SOAH DOCKET NO. 473-22-0768 PUC DOCKET NO. 52455

APPLICATION OF ONCOR	§	BEFORE THE STATE
ELECTRIC DELIVERY COMPANY	§	
LLC TO AMEND ITS CERTIFICATE	§	
OF CONVENIENCE AND	§	
NECESSITY FOR THE OLD	§	OFFICE OF
COUNTRY SWITCH 345-KV TAP	§	
TRANSMISSION LINE IN ELLIS	Š	
COUNTY, TEXAS (OLD COUNTRY	Š	
SWITCH CCN)	š	ADMINISTRATIVE HEARINGS

RESPONSE OF ONCOR ELECTRIC DELIVERY COMPANY LLC TO CHAMBERS CREEK RANCH'S SECOND REQUESTS FOR INFORMATION

National Flood Hazard Layer FIRMette

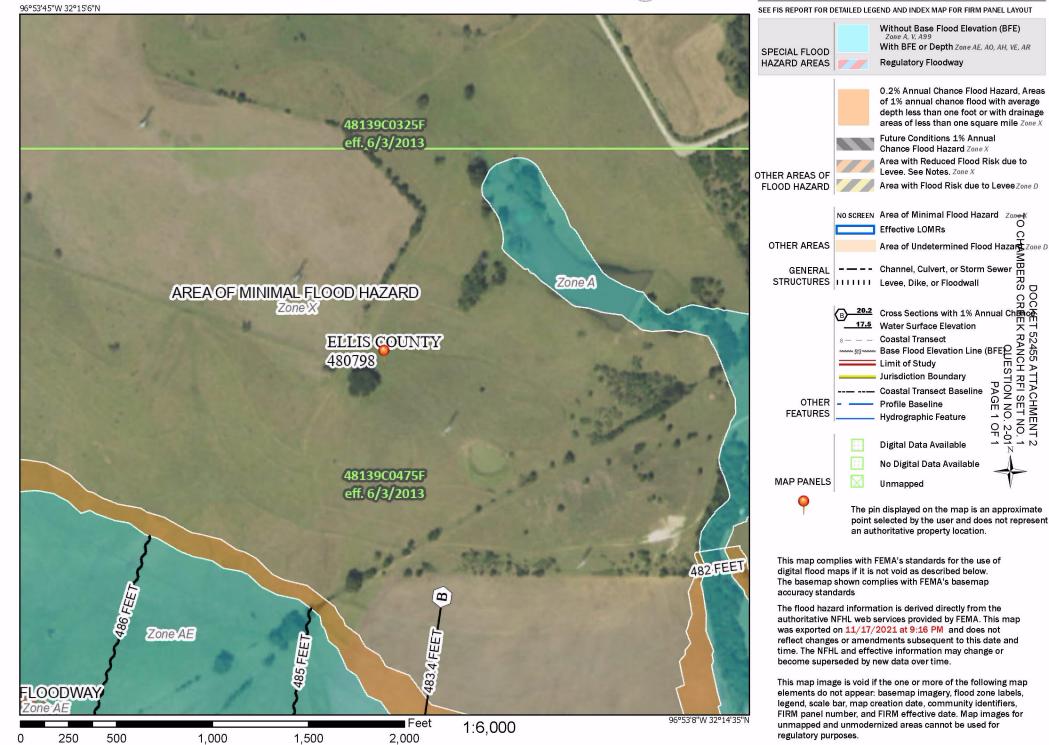
- e. Please provide any topographical maps Oncor has of the site near Substation Option 3, that would support Oncor's characterization of the site have "undesirable topography."

- f. Please provide a detailed narrative explaining what makes the topography of Substation Option 3 "undesirable."
- g. Please confirm that Substation Option 3 is not in a FEMA floodplain. If this cannot be confirmed, please provide a detailed narrative explaining the response.

- d. Oncor does not have photographs of the site near Substation Option 3.
- e. Please see the Federal Emergency Management Agency ("FEMA") floodplain map included as Attachment 2 hereto.

- f. As shown in Attachment 2, Substation Option 3 is surrounded on three sides by FEMA flood hazard areas, including a sizeable valley that lies directly between Substation Option 3 and Bill Lewis Road. In order to reliably access Substation Option 3, Oncor would need to construct an access road that circumnavigated the valley, resulting in a longer, more circuitous route, which would add to the expense of the project.

- g. As shown in Attachment 2, Substation Option 3 is in an area of minimal flood hazard, but is surrounded on three sides by FEMA flood hazard areas.
- h. Attachment 1 Old Country Switch Station Locations Map was created using the shapefiles provided to Chambers Creek Ranch in Oncor's response to Chamber Creek Ranch's RFI Set 1, Question No. 1-01. The proposed transmission line and potential station locations were drawn on a PDF version of the map.

ATTACHMENT 1 – FEMA floodplain map – 1 page

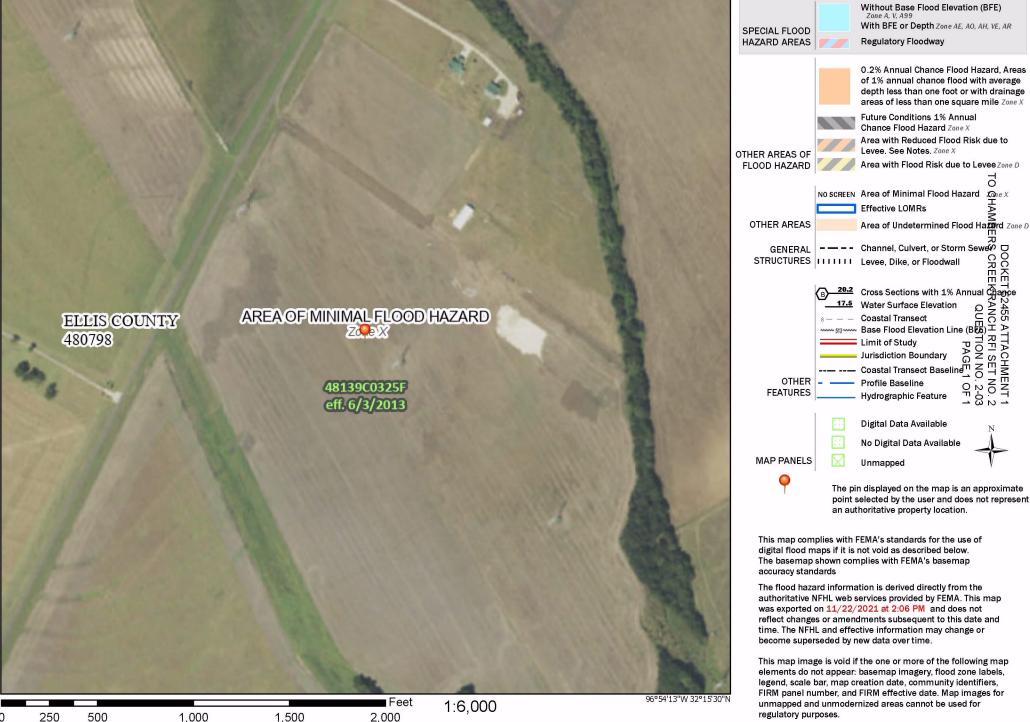
- a. Please provide a detailed explanation of what makes this substation location "less reliable."
- b. Please provide any and all studies, reports, analyses, etc., that support Oncor's assertion that this substation location is less reliable.
- c. Please provide any and all studies, reports, analyses, GIS data, etc., that support Oncor's assertion that this substation location has sub-optimal terrain.
- d. Please provide any and all studies, reports, analyses, GIS data, etc. that supports Oncor's assertion that this substation location is "more flood prone than the location selected by Oncor."
- e. Please confirm that if the Commission required Oncor to construct the Old Country Switch at this location, it would do so.

- Locating stations in or near flood-prone areas hinders reliability. Flooding at an electric substation can cause equipment to fail and present a significant safety hazard. With respect to Substation Option 3, the presence of flood zones on three sides of the site, including directly between Substation Option 3 and Bill Lewis Road, could hinder access to the site. The ability to access facilities for maintenance and/or repairs is a key component of reliability.

- d. Please see the maps included as Attachment 1 hereto and as Attachment 2 to Oncor's response to Chambers Creek Ranch's RFI Set No. 2, Question No. 2-01. These attachments are 1:6,000 scale FEMA floodplain maps respectively showing: (1) Oncor's chosen location for the Old Country Switch station; and (2) the location of Station Option 3; both overlain with FEMA flood hazard data. As shown in Attachment 1, there are no special flood hazard areas located within approximately 2,000 feet of Oncor's chosen location for the Old Country Switch station. By contrast, Station Option 3 is surrounded on three sides by FEMA flood zones and in close proximity to a

regulatory floodway.
